LANSDOWNE PARK HIA ADDENDUM

Date: September 25, 2023
Issued To: Lansdowne Park Redevelopment Project
Planning, Real Estate and Economic Development, City of Ottawa
110 Laurier Avenue West
Ottawa, Ontario, K1P 1J1
Prepared by: PE / SI / EC / CH

This memo has been prepared by ERA Architects Inc. (ERA) as an addendum to the Heritage Impact Assessment (HIA), for the property known as Lansdowne Park (the “Site”), dated June 29, 2023 (June 2023 HIA). The June 2023 HIA provided a heritage impact analysis for the proposed development (Three-Tower Concept). As a result of comments received through public consultation and City Staff review, the proposed development has been amended. The revised proposal consists of a two-tower development concept (Two-Tower Concept). The key changes from a heritage perspective include:

Birds eye view of the Two-Tower Concept (Hobin Architecture Inc., September, 2023).

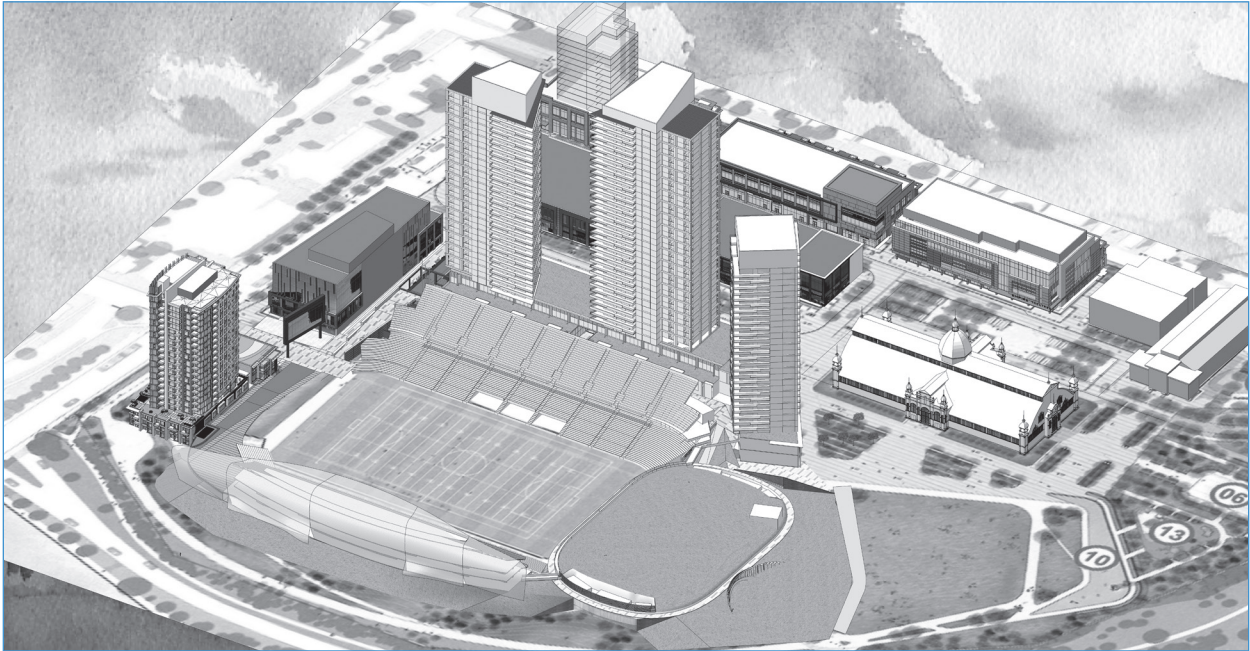
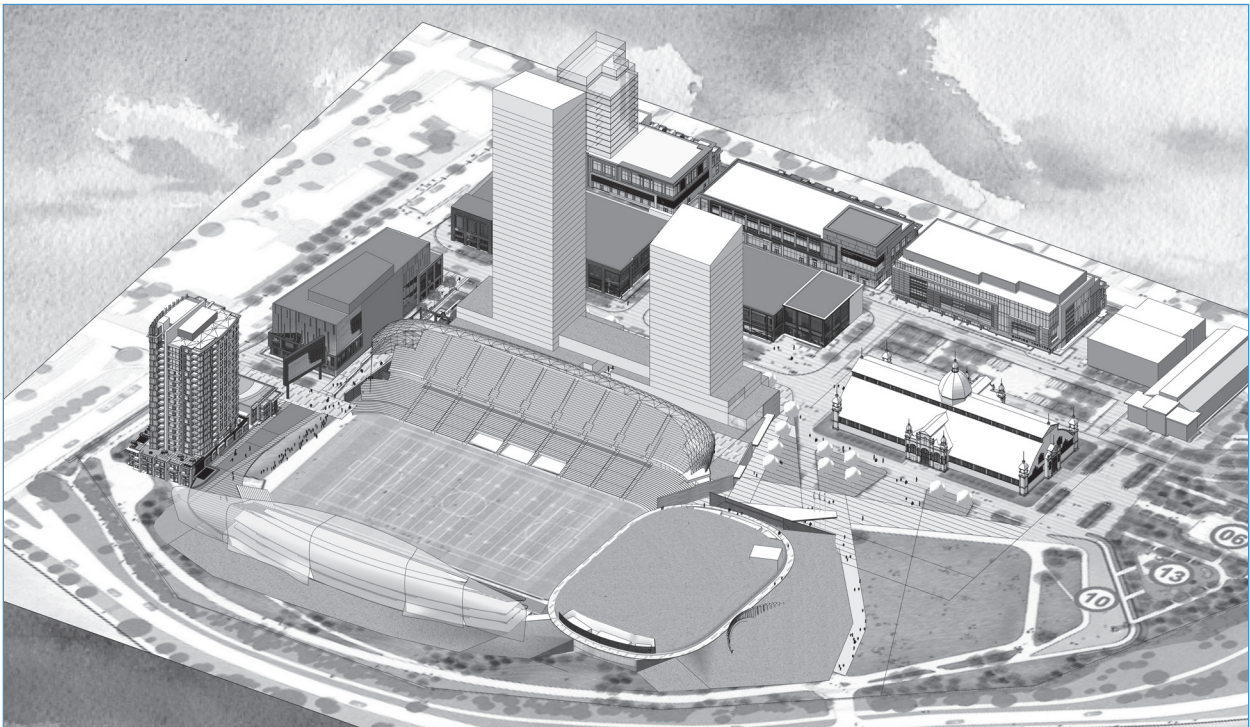
The proposed development, as outlined in the June 2023 submission, has been revised to remove the third residential tower located closest to the Aberdeen Pavilion, resulting in a Two-Tower Concept of 40 and 25 storeys in height. The proposed floorplate sizes of the towers have been reduced from approximately 900 square metres to approximately 800 square metres. The overall unit count has decreased from 1200 units to 770 units (distributed between the two towers and potential residential podium).

The retail podium is proposed as a two-storey built form, consistent with the June 2023 submission. As in the previous submission, the residential portion of the podium will be stepped back from the edge of the retail podium. The Two-Tower Concept removes the music hall and upper level retail space resulting in a decrease in the podium size from approximately 10,000 square metres to approximately 4,600 square metres.

The Two-Tower Concept provides increased tower separation from both the Aberdeen Pavilion and the towers themselves. Additional changes include: reduced underground parking, reduced shadow impact, and an enhanced pedestrian realm adjacent to the Aberdeen Pavilion.

Two-Tower Concept: View from Queen Elizabeth Driveway toward the Site (ERA, September, 2023).

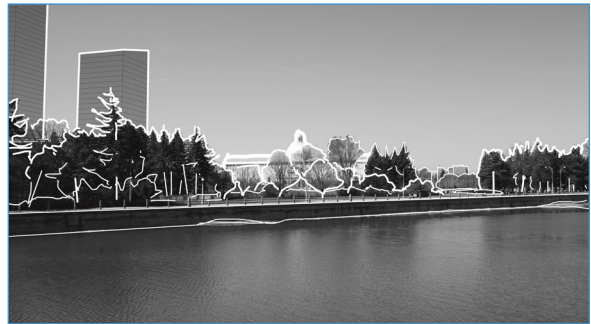
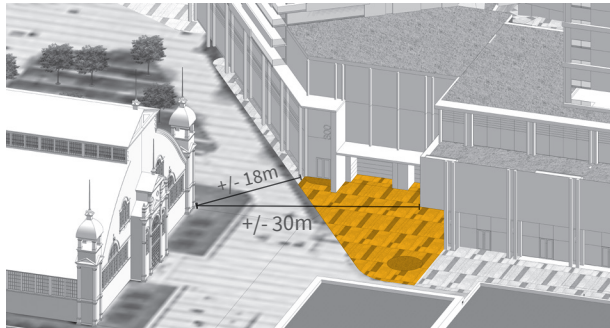
The proposed Two-Tower Concept will continue to impact the visual prominence of the Aberdeen Pavilion from certain vantage points within and adjacent to the Site. The proposed towers will be visible beyond the silhouette of the Aberdeen Pavilion as defined in the 2012 Heritage Conservation Easement Agreement (HCEA) protected Viewpoints "C" and "D". As in the June 2023 submission, the redesigned retail podium in the Two-Tower concept will open views to the Aberdeen Pavilion from the central axis along Bank Street, creating a positive impact on Viewpoint "G". The removal of the third tower slightly reduces the impact on the affected HCEA Viewpoints and dynamic views of the Site from the Rideau Canal and NCC lands to the south and east (when compared to the previous proposal). The reduced density and tower placement in the Two-Tower Concept provides additional open sky in the silhouette view and slightly enhances the legibility of the roofline of the Aberdeen Pavilion in Viewpoints "C" and "D".

View of the Two-Tower Concept (Hobin Architecture Inc., annotated by ERA, September, 2023).

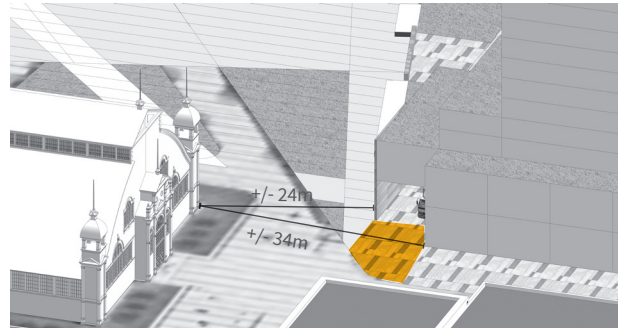
The removal of the east tower closest to the Aberdeen Pavilion creates a greater separation between the heritage resource and the proposed development. The removal of the third tower and its podium base allows for improved at-grade conditions for pedestrians, while creating a greater separation of uses and additional space for loading access at the northeastern edge of the proposed development.
